101 Camley Street, Camden

Section 73 Minor Material Amendments Application to the London Borough of Camden

July 2018

This document has been produced to track the main amendments to the design between the Minor Material Amendments Application in December 2016 and the completion of the Stage 04 Detailed Design. These amendments have been necessary to implement in order to make the scheme technically viable.

Lower Ground Floor Plan. Scale 1:200 at A3.

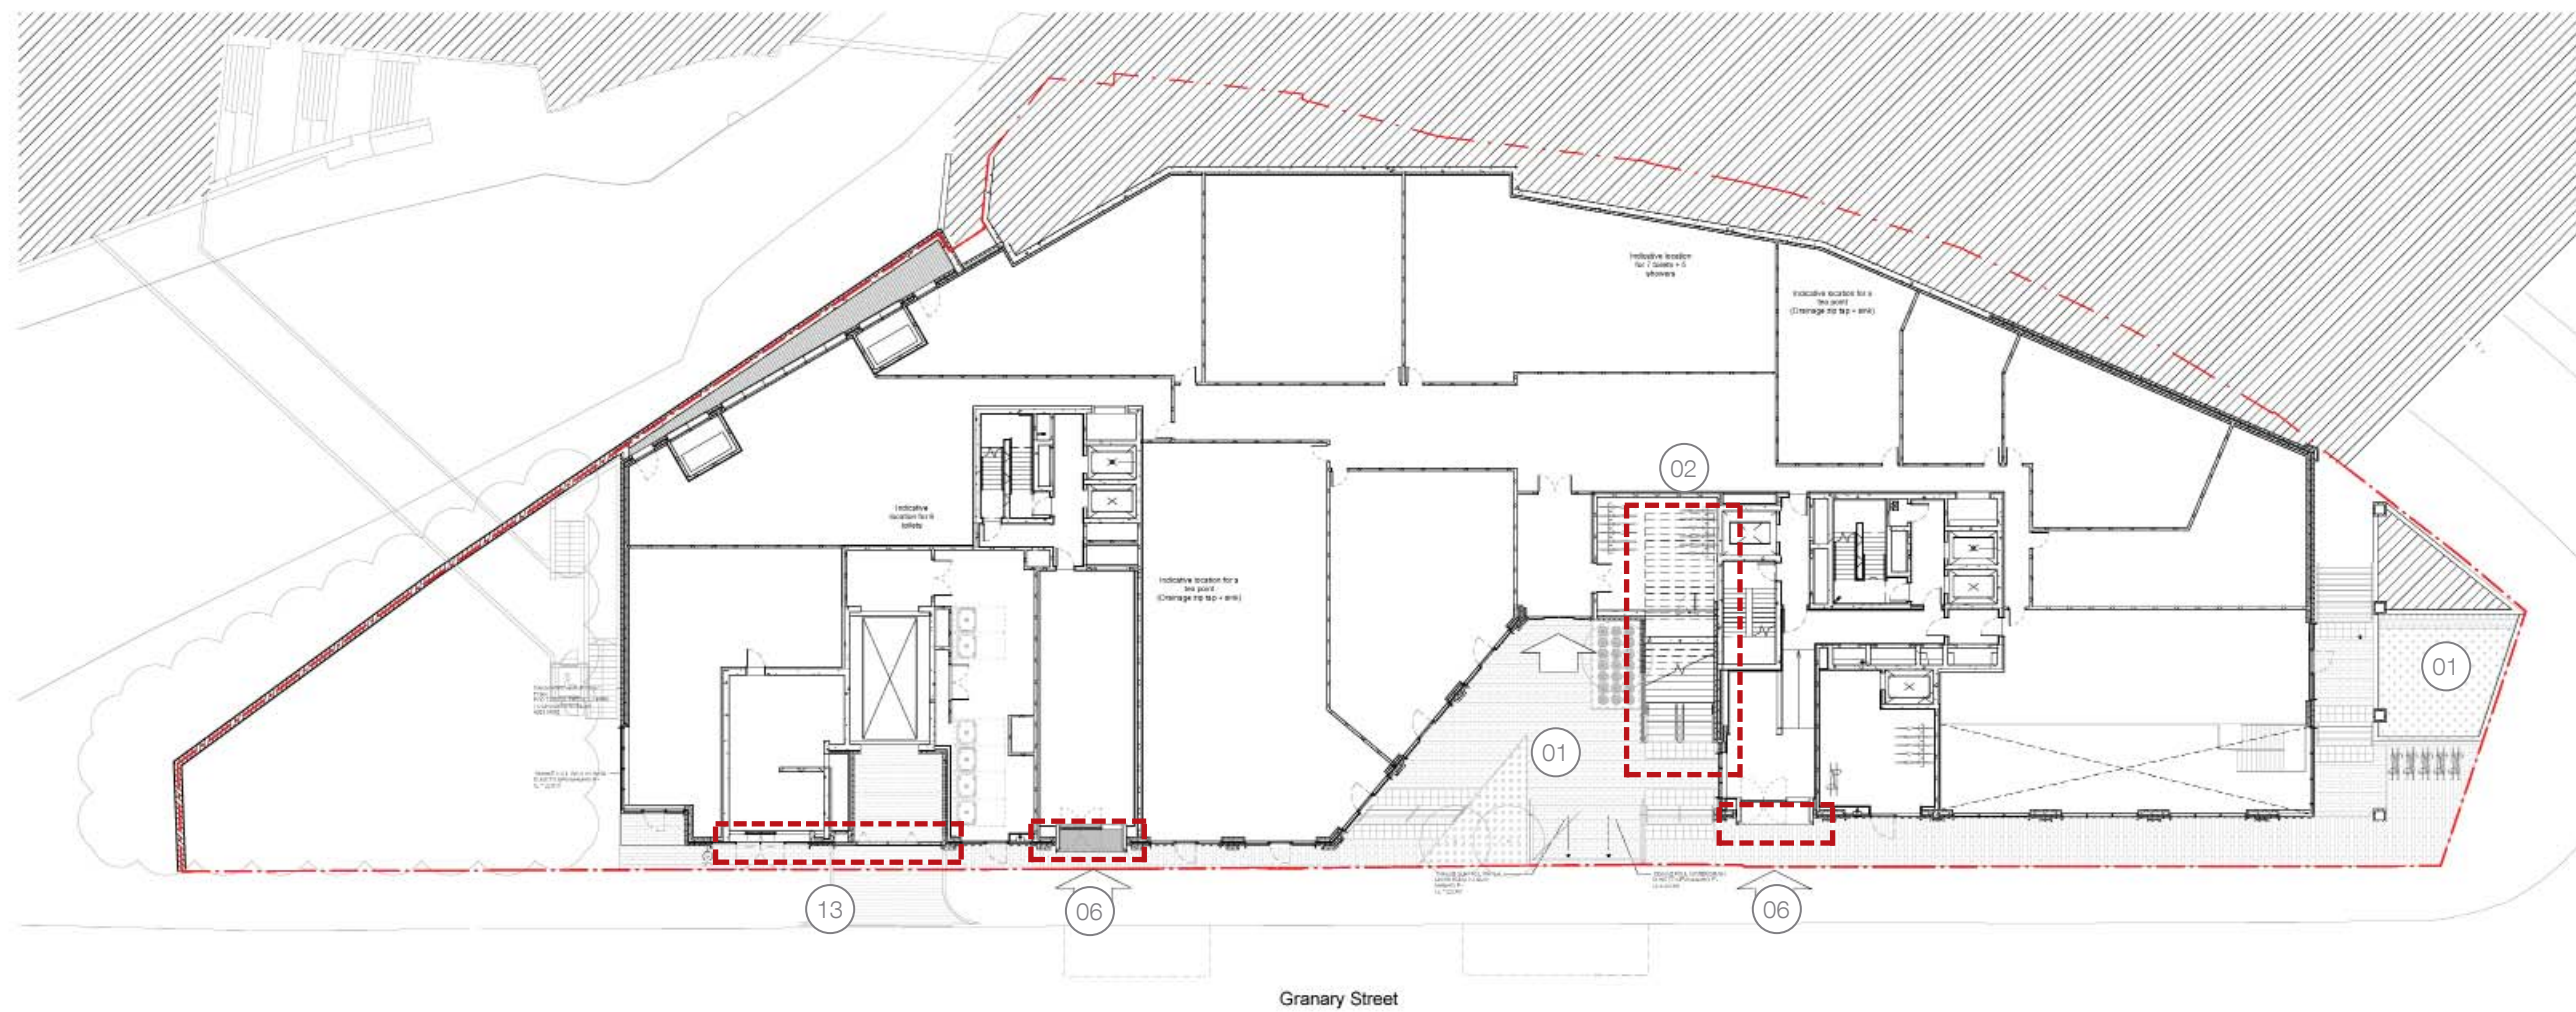
- Outline of affected areas.
- 01. Landscape general updates.
- 02. Change to external staircase.
- 06. Residential entrances canopies.
- 13. Substation decorative screens.

Upper Ground Floor Plan. Scale 1:400 at A3.

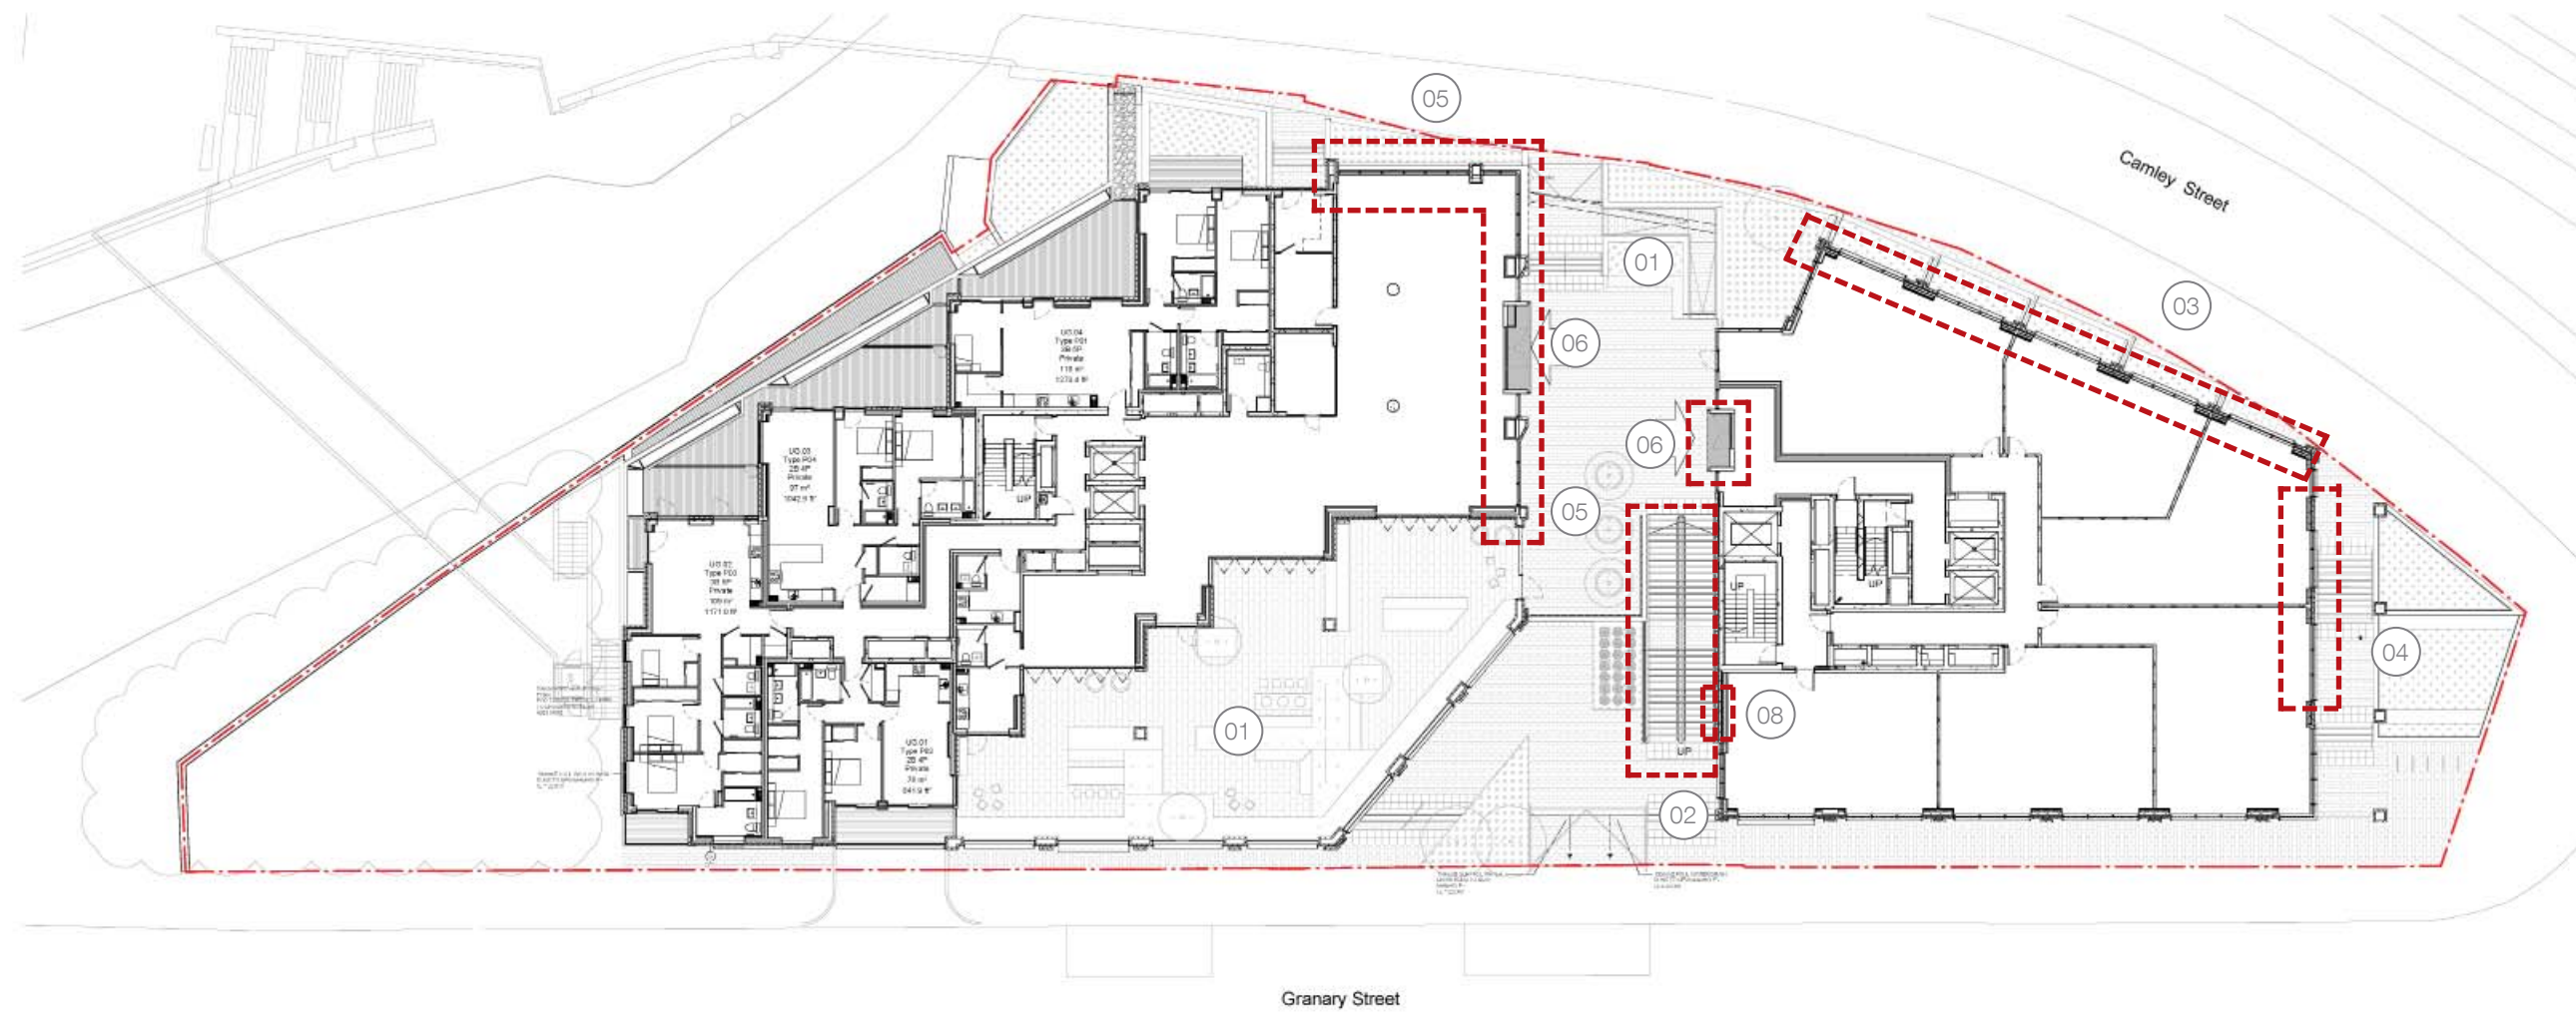
- Outline of affected areas.
- 01. Landscape general updates.
- 02. Change to external staircase.
- 03. Upper ground level spandrel panel depth.
- 04. Insertion of fire door.
- 05. Residential lobby glazing.
- 06. Residential entrances canopies.
- 08. Window to NW elevation South Building.

Typical Ground Floor Plan. Scale 1:400 at A3.

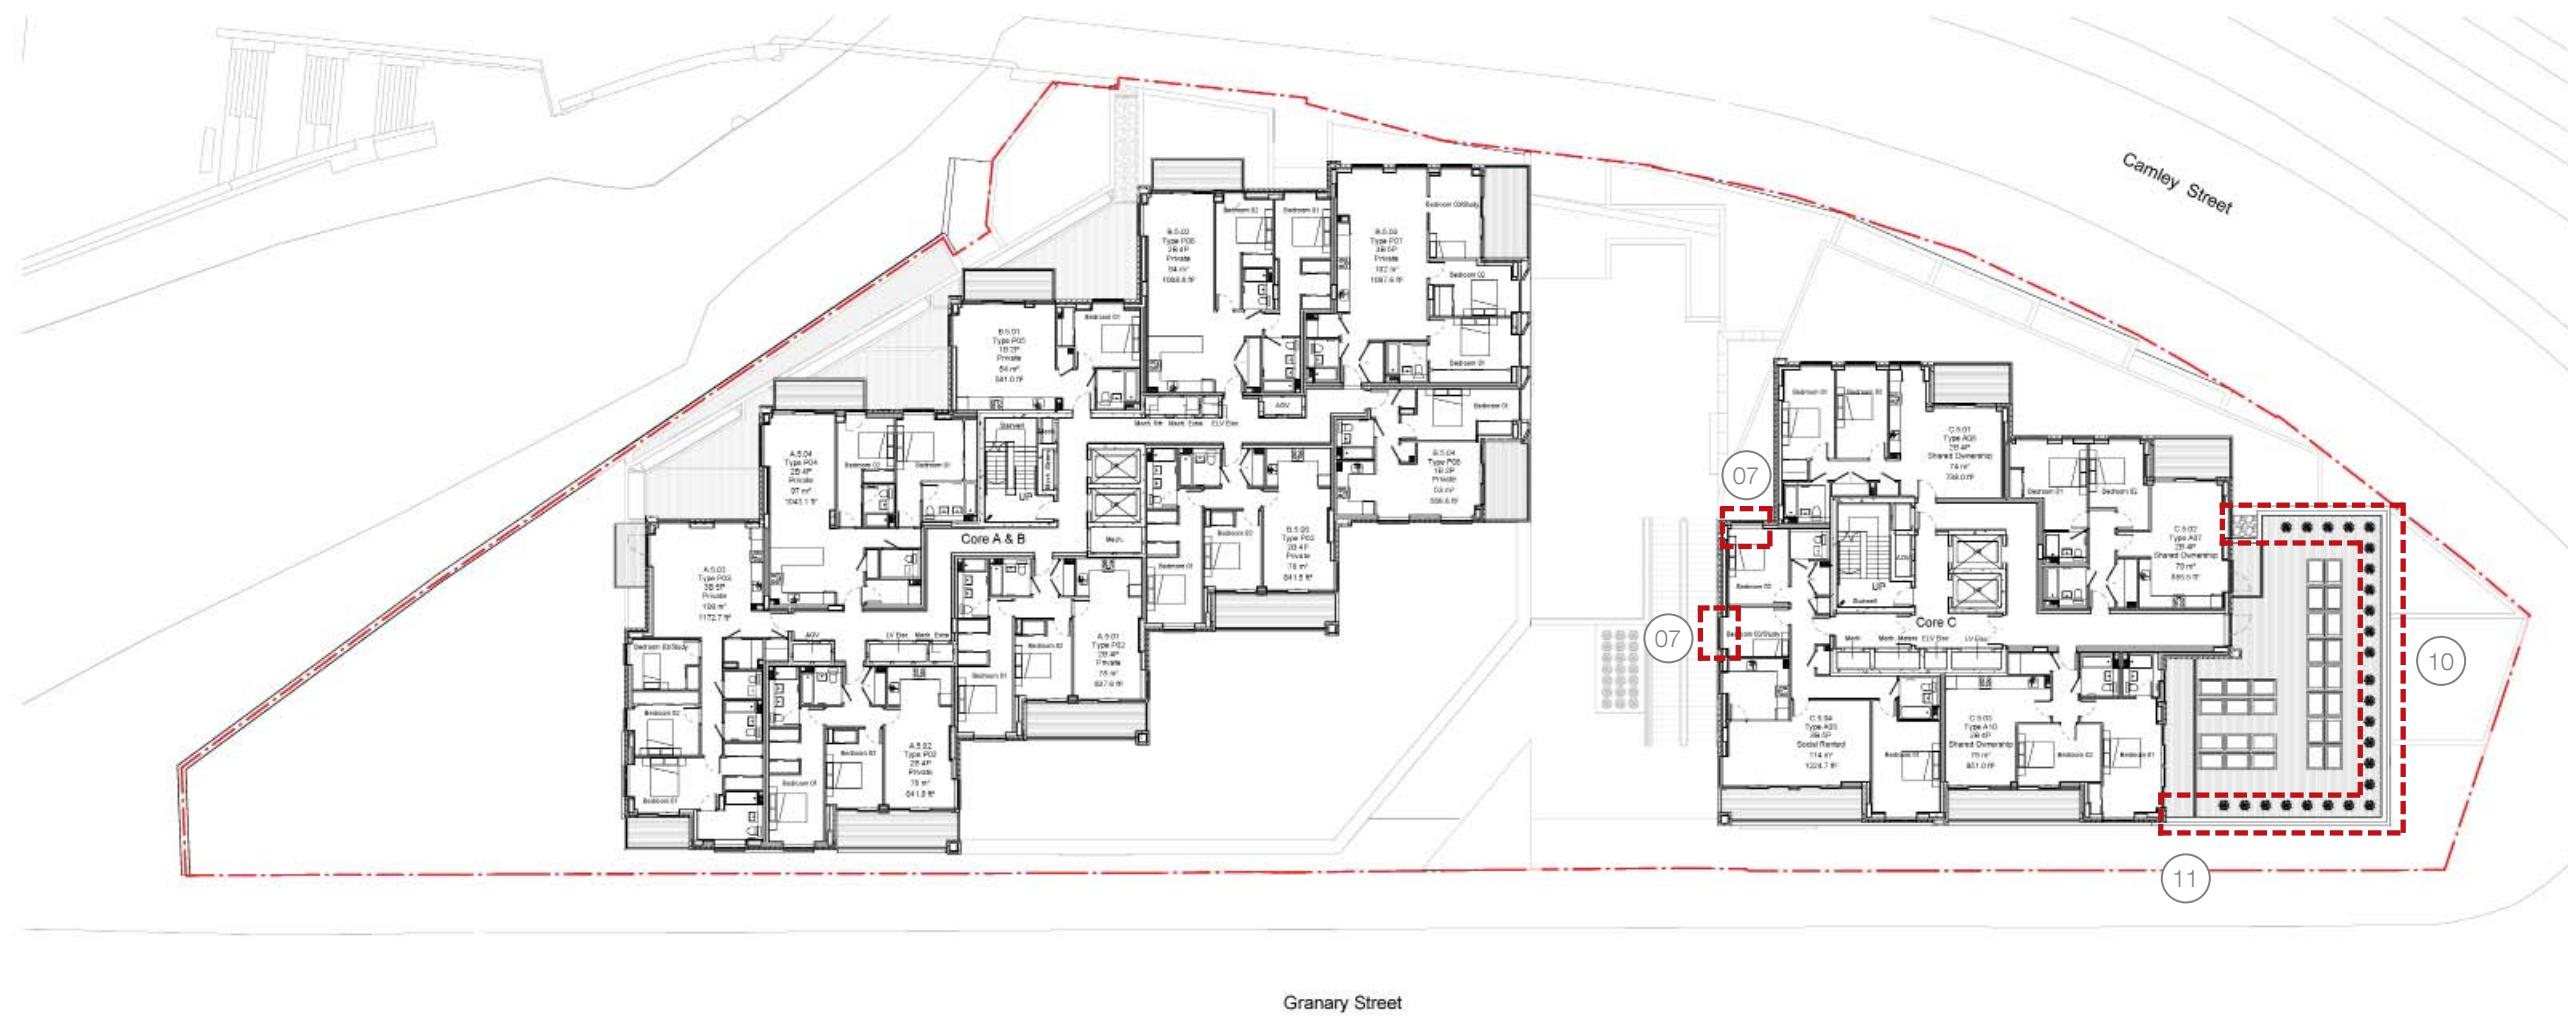
- Outline of affected areas.
- 07. Protruding window at South Block.
- 10. Terrace edge protection.
- 11. Parapet connection to glazed corners.

SW Elevation. Scale 1:400 at A3.

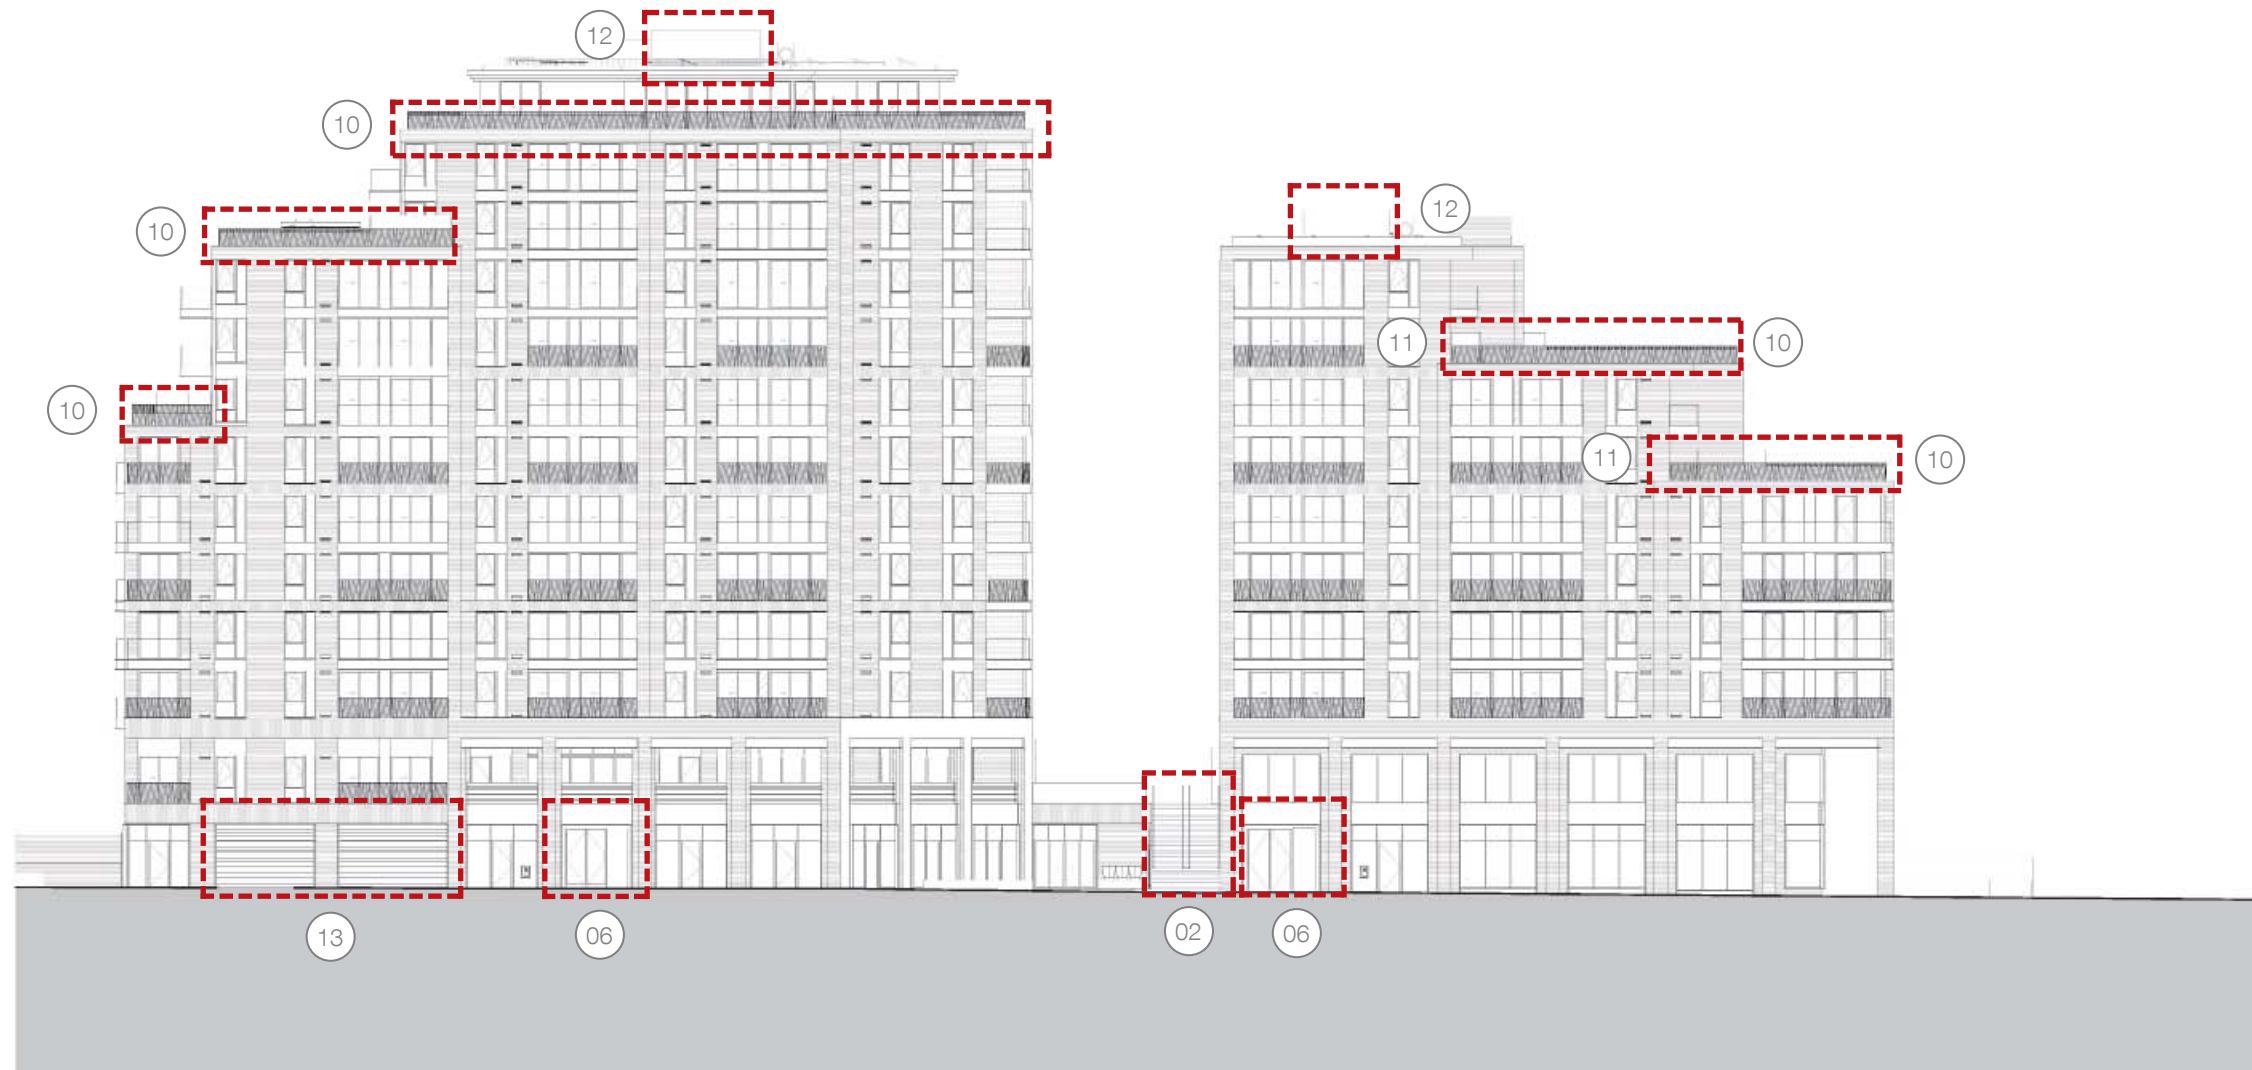
- Outline of affected areas.
- 02. Change to external staircase.
- 06. Residential entrances canopies.
- 10. Terrace edge protection.
- 11. Parapet connection to glazed corners.
- 12. Acoustic enclosures at roof level.

13. Substation decorative screens.
